THE BELT RAILWAY COMPANY OF CHICAGO

System General Order

#2026-001

Subject: System General Order #2026 - 001

9.1.3 RESTRICTING:

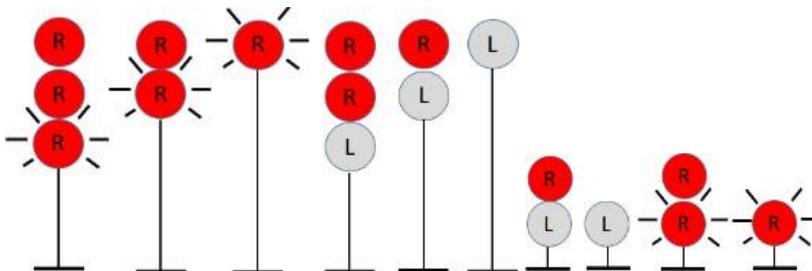
Aspects shown apply when displayed on a signal with, or without, a number plate.

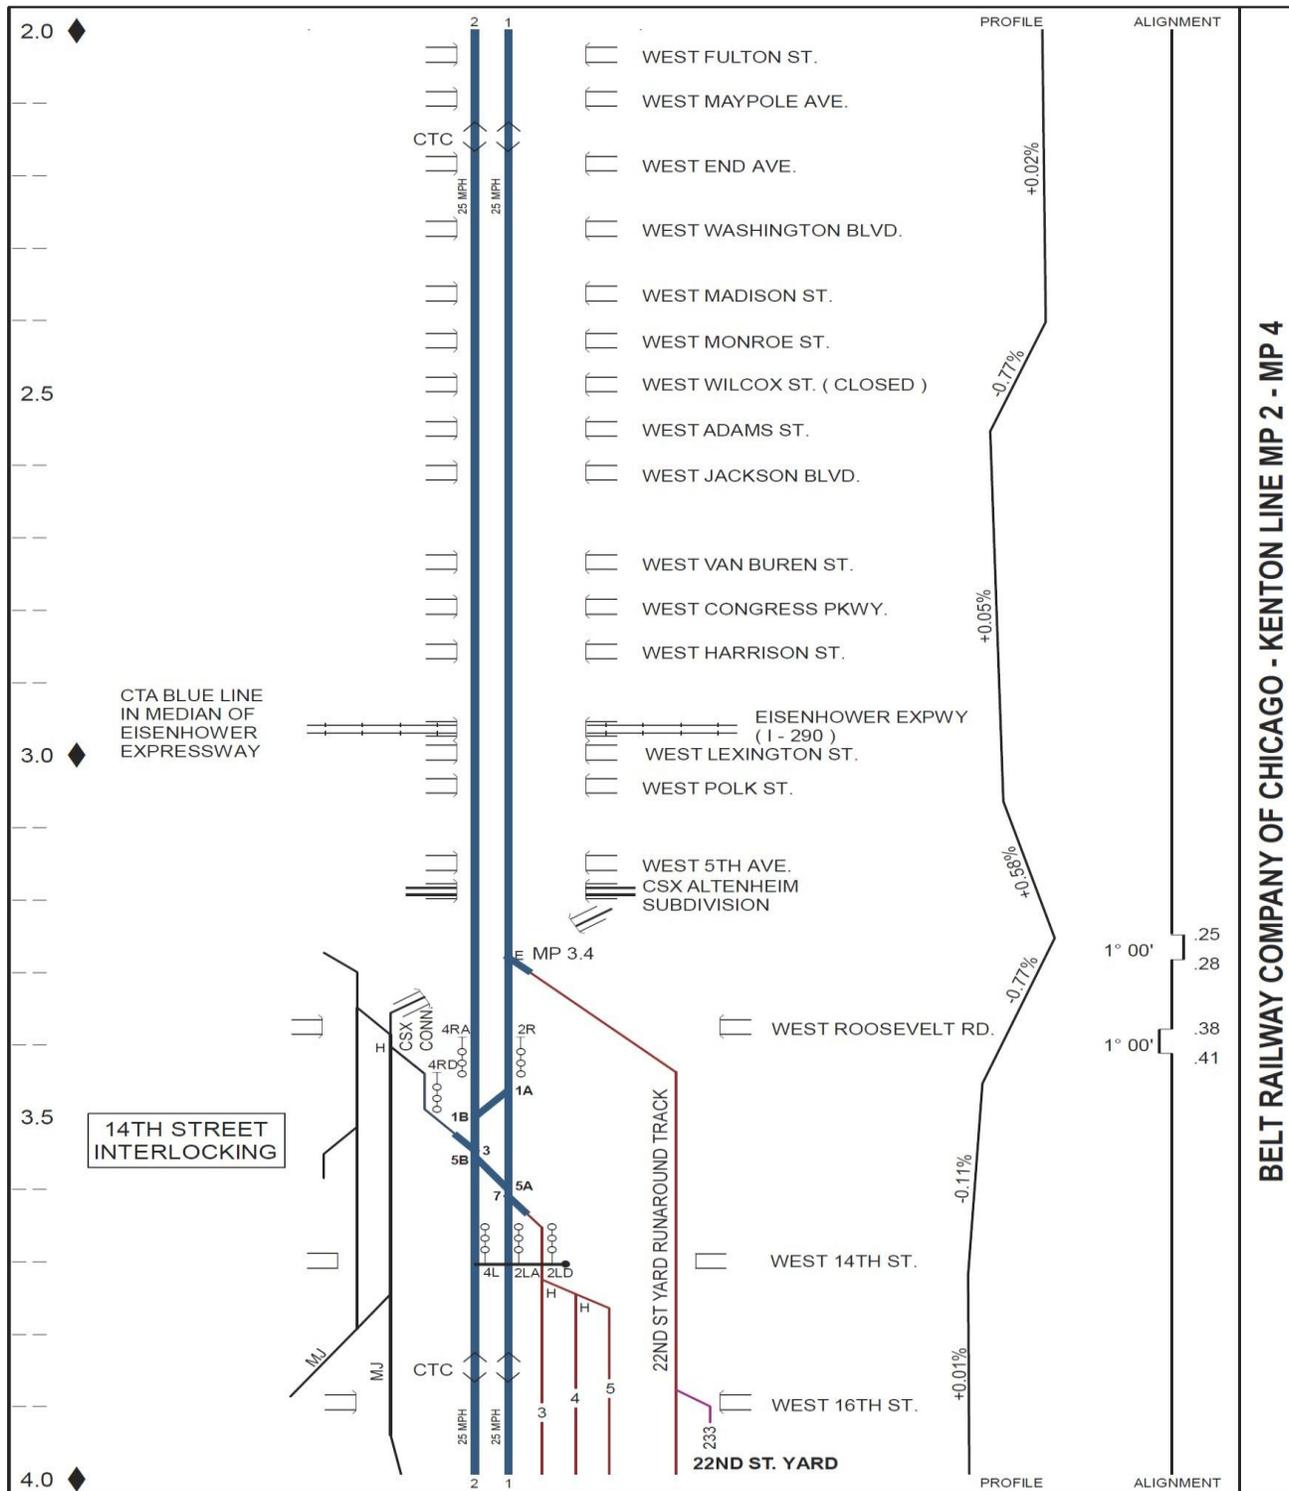
Please refer to the updated Linear Profile at the end of the System General Order, which reflects all changes between MP 12.0 & MP 14.0 on the BRC Kenton Line.

Add the following map to Timetable #7, replacing Page 98:

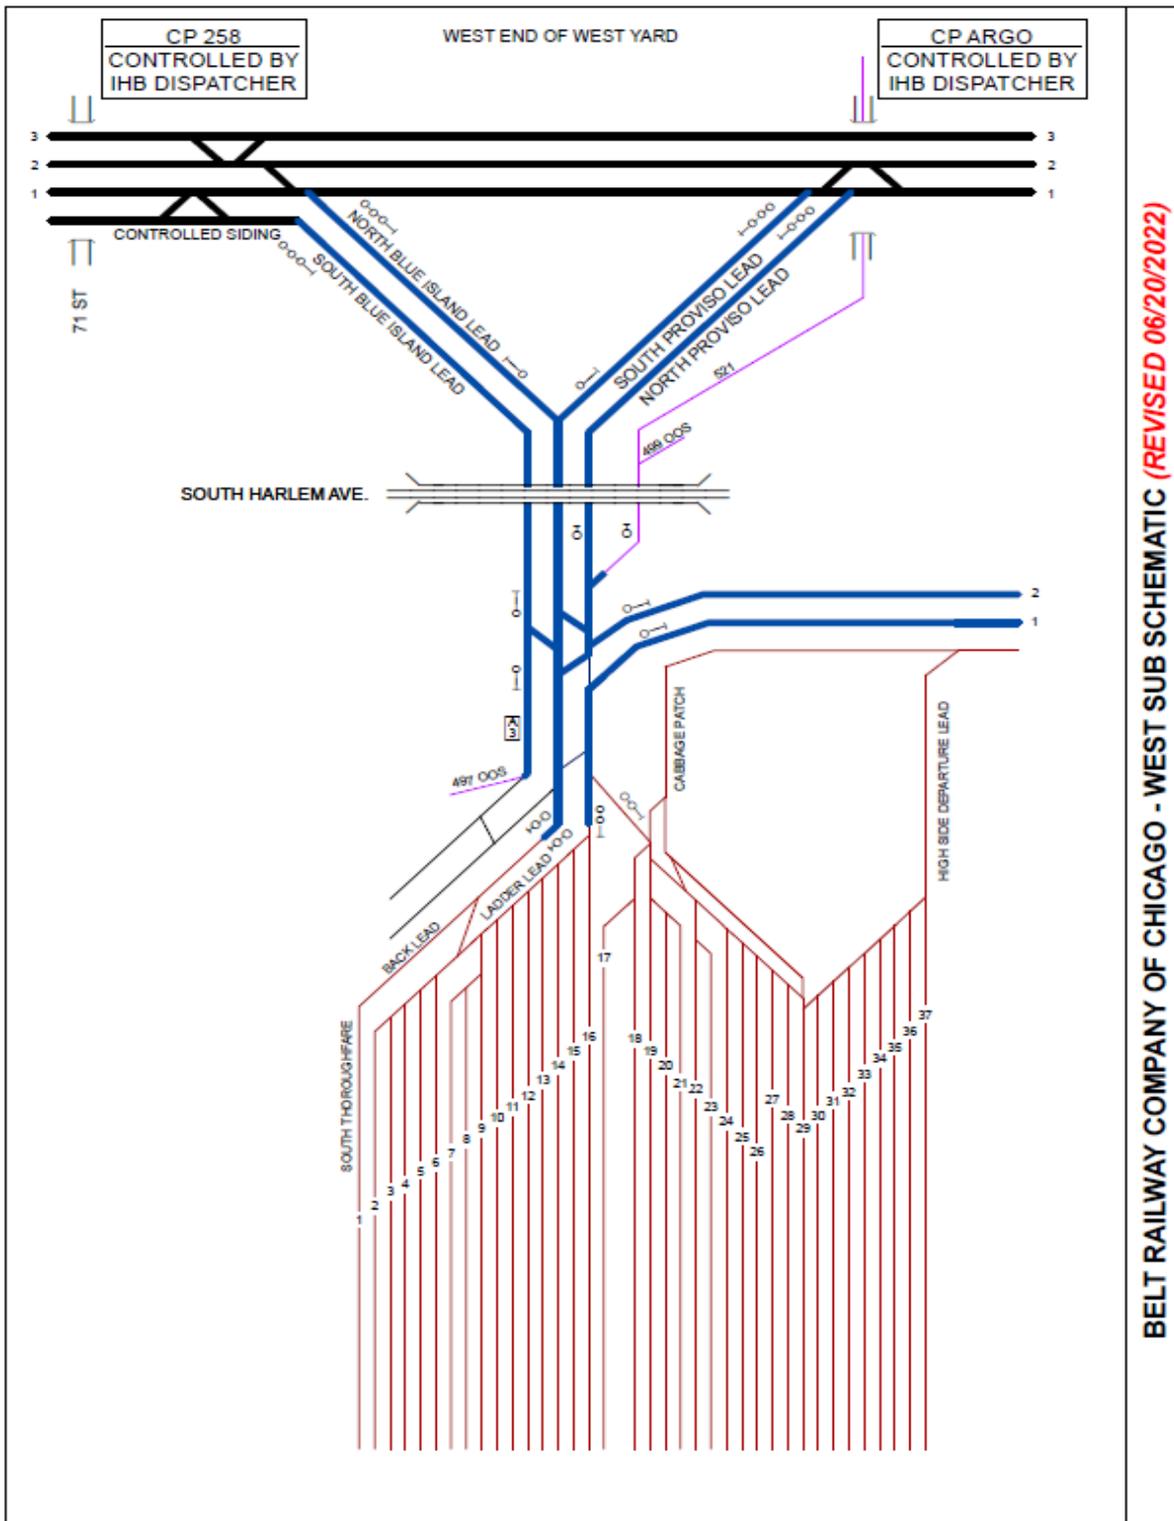
West End West Yard (page 98 Timetable #7)

The BRC North & South Proviso Leads now individually connect to the IHB Main Track 1 within the IHB CP Argo Interlocking.

New signals governing movement from the BRC North & Proviso Lead to the IHB Main Line has been placed in service.

The Location of the signals governing movement from the BRC North & South Proviso to IHB are located appx 850 feet south from previous cantilever signal that controlled movement from the BRC

North & South Proviso Leads to IHB.

North and South Proviso Lead Signals are displayed on the left-hand side as viewed by approaching trains.

Show the North & South Proviso Lead tracks as CTC Main Tracks
